20 Feb 1896

P.S. "Armon"

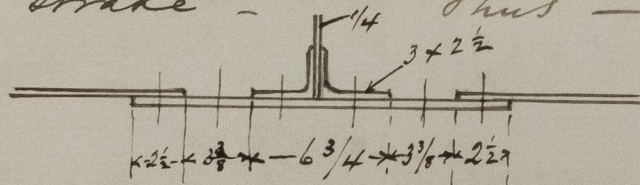
The spacing of rivets in the butts of the flat keel plate is correct as I have given it namely 3".

It was not possible to get more than one rivet between the intercostal angle and the landing of the garboard strake - Thus -

There are 3 complete rows of rivets in these butts which compensates for the wider spacing - In order not to delay the classing I have wired Mr. Jordan to this effect -
